**Piceance Energy LLC
Harrison Creek Water Treatment
Facility – DAF Unit**

OA Project No. 014-0465

March 18, 2015

Olsson Associates (Olsson) has reviewed the *Drainage Report for Harrison Creek Produced Water Recycling Facility Mesa County, Colorado* prepared by Rhino Engineering, Inc. Revised June 25, 2009 (Report). Additionally, Olsson has reviewed the Harrison Creek Water Treatment Facility Civil Layout and Grading Plan prepared by Samuel Engineering, signed and sealed March 18, 2015 (Grading Plan). The purpose of the review is to determine whether the Grading Plan is in general conformance with the Report. Calculations and study is not included with this review.

TITLE	PROJECT NO.
HARRISON CREEK WATER TREATMENT FACILITY CIVIL LAYOUT AND GRADING PLAN	14130
	DRAWING NUMBER
	0100-CE-101

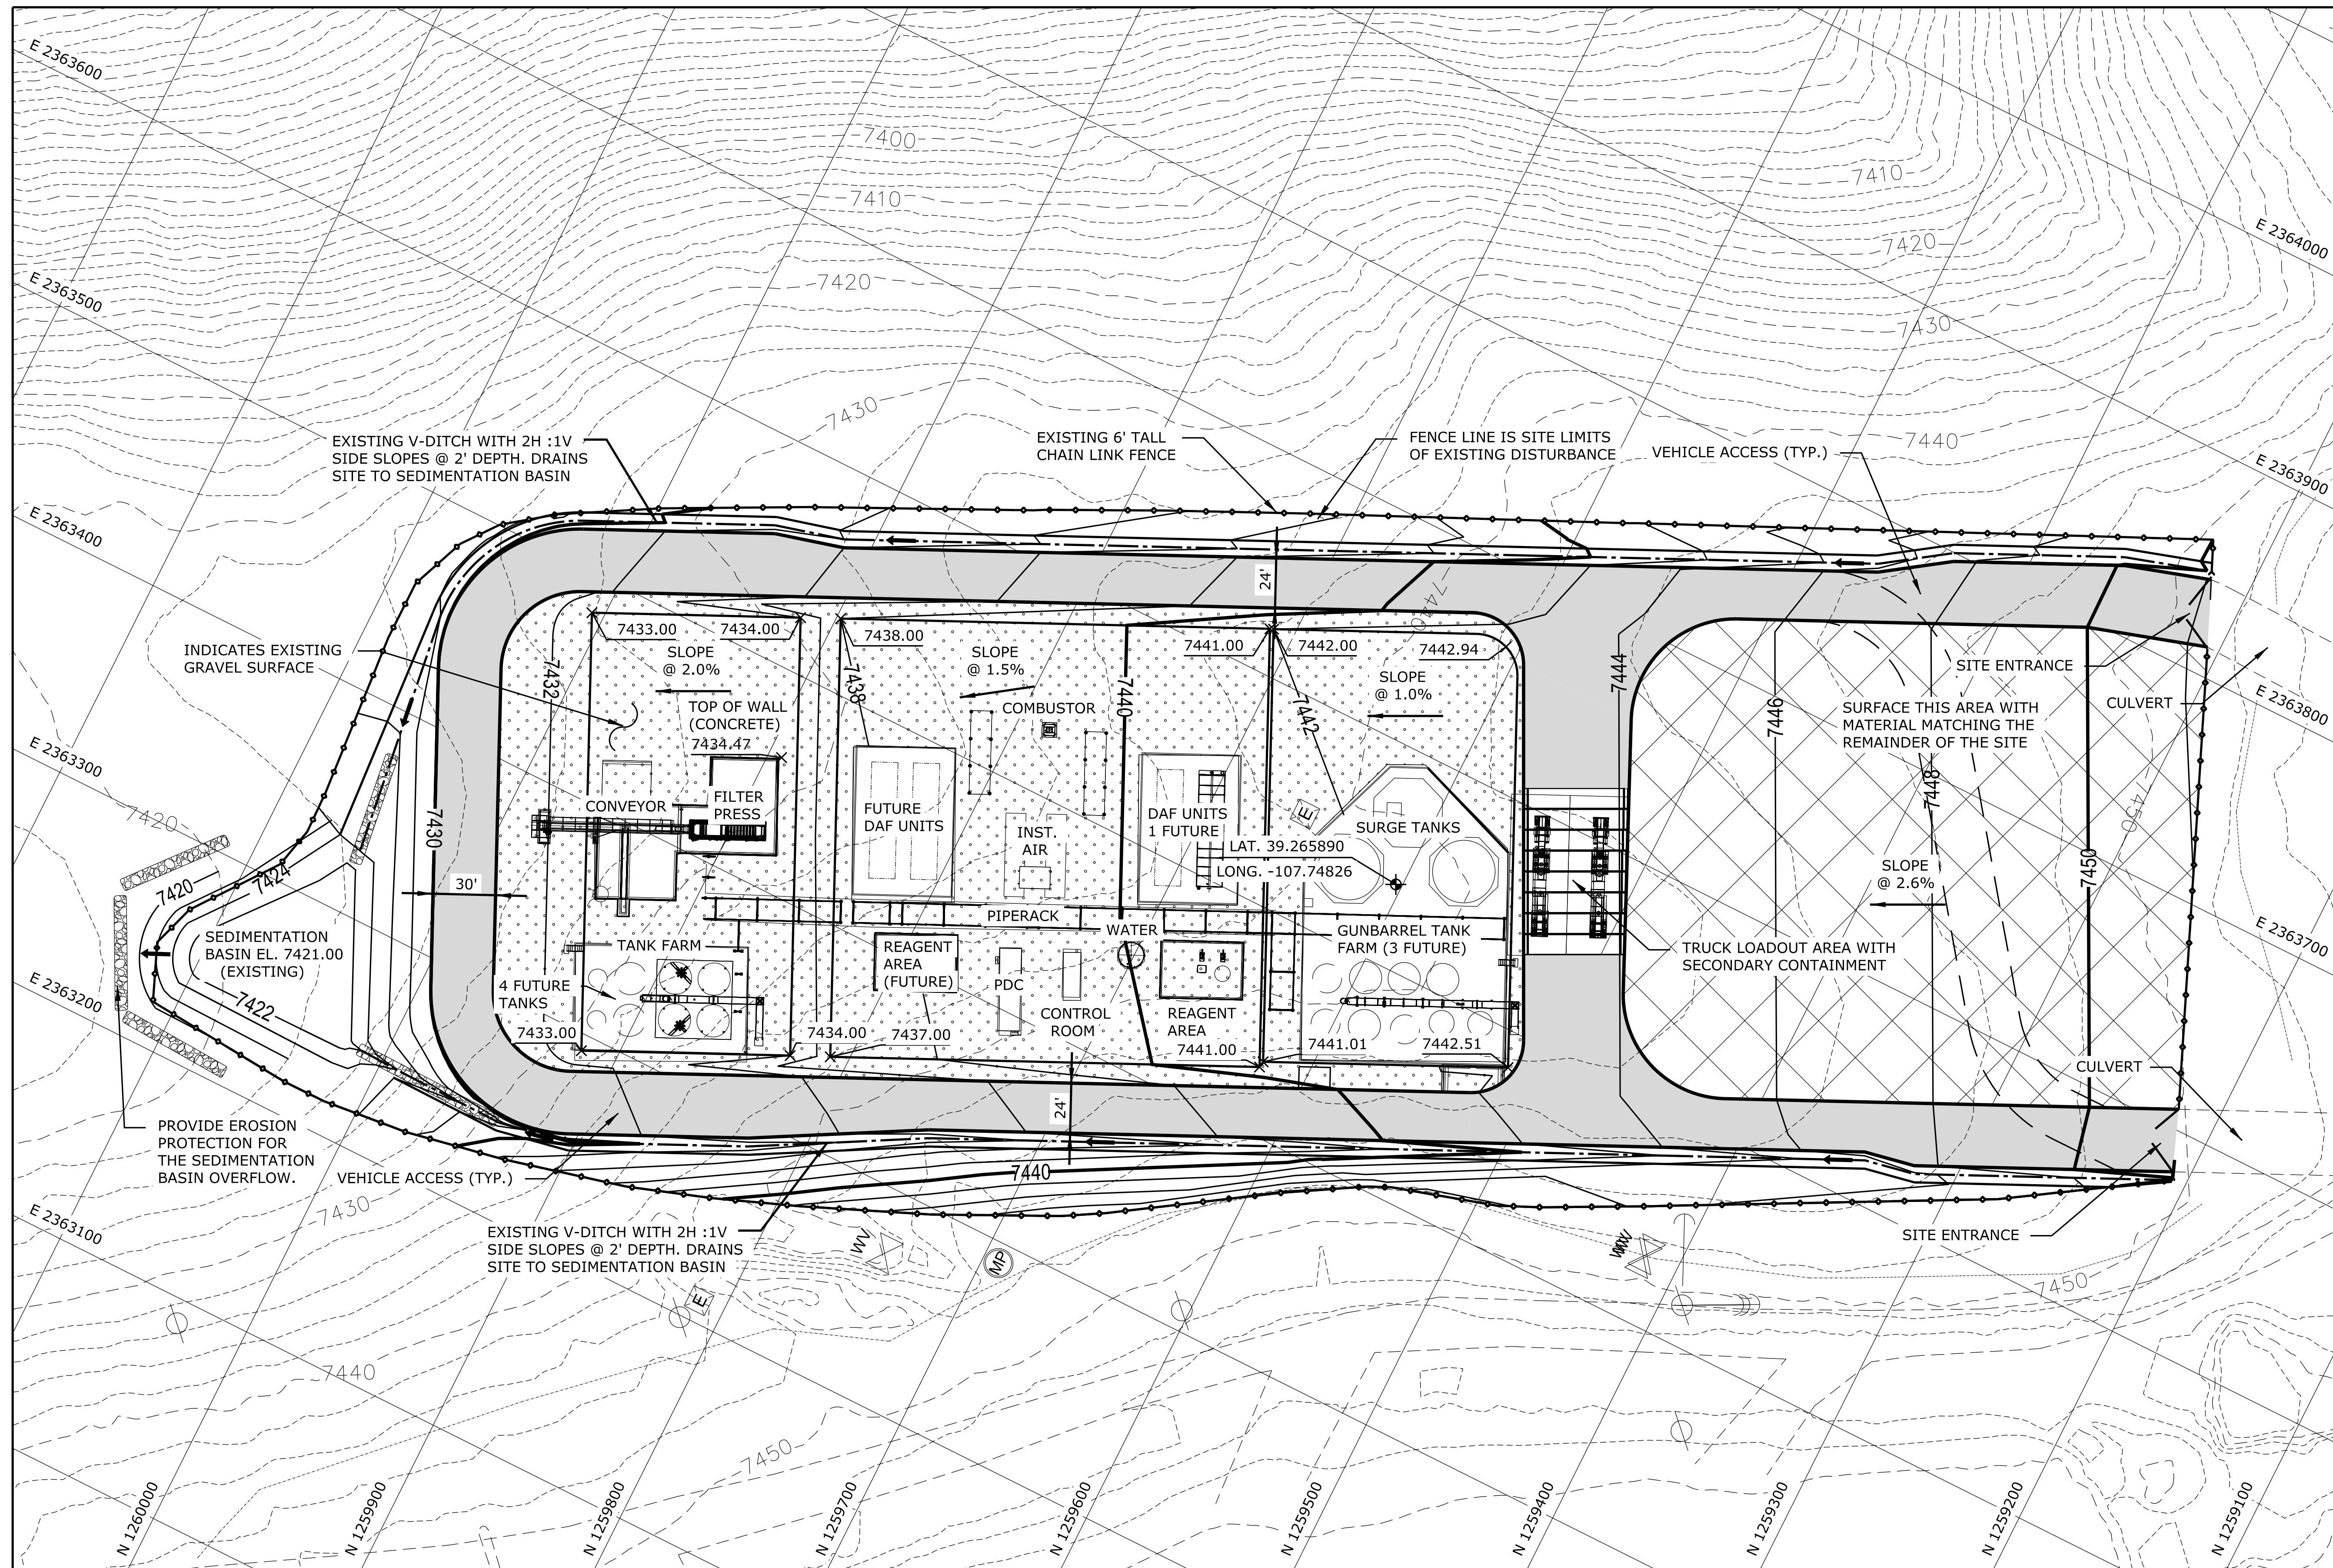
There are a few items of note that require some additional verification between the Grading Plan and the Report:

- The Report indicates there are two 18" CMP culverts on the south end of the site
 - The culverts convey the existing irrigation ditch under the perimeter access roads
 - The Grading Plan identifies culverts, however, the size is not indicated
- The Report indicates an 18" CMP culvert within the conveyance swale along the west side of the site

- The Grading Plan does not indicate the culvert, however, it shows the V-ditch along the entire length
- The Report indicates that the Sedimentation Basin shown within the grading plan is a detention basin
 - The Report indicates there is a 12" HDPE outlet pipe, however, the Grading Plan does not indicate that there is an outlet pipe
 - Additionally, the Report indicates the pond bottom to have an elevation of 7411 feet with a top elevation of 7415 feet, however, the Grading Plan indicates the pond bottom elevation is 7421 feet and it appears the top elevation may be 7425 feet

In conclusion, the Grading Plan appears to be in general conformance with the Report with two exceptions:

1. The detention pond described within the Report appears to be of similar volume, similar side slopes, and similar depth, however, it does not appear to function as designed. The Report designed the pond to release the flow through an outlet pipe. The Grading Plan appears to treat the pond as a sedimentation basin and does not allow for an outflow. The outflow would require overtopping the pond.

2. The west conveyance ditch is designed within the Report to include a culvert in a portion of the ditch. This appears to have been included due to grading constraints that would prevent an open channel ditch.

It is recommended that the detention pond be modified to include the outlet pipe as designed within the Report. Alternatively, the existing pond could be modified to include a weir outfall to meet the intent of the pond release designed within the Report.

It is recommended that this area be investigated further to determine that the ditch section is maintained throughout the area and verify that the grading anticipated within the Report was modified to allow for an open channel. Alternatively, a culvert may need to be installed to meet the design intent of the Report should additional verification confirm that the channel section does not meet the intent of the design of the Report.
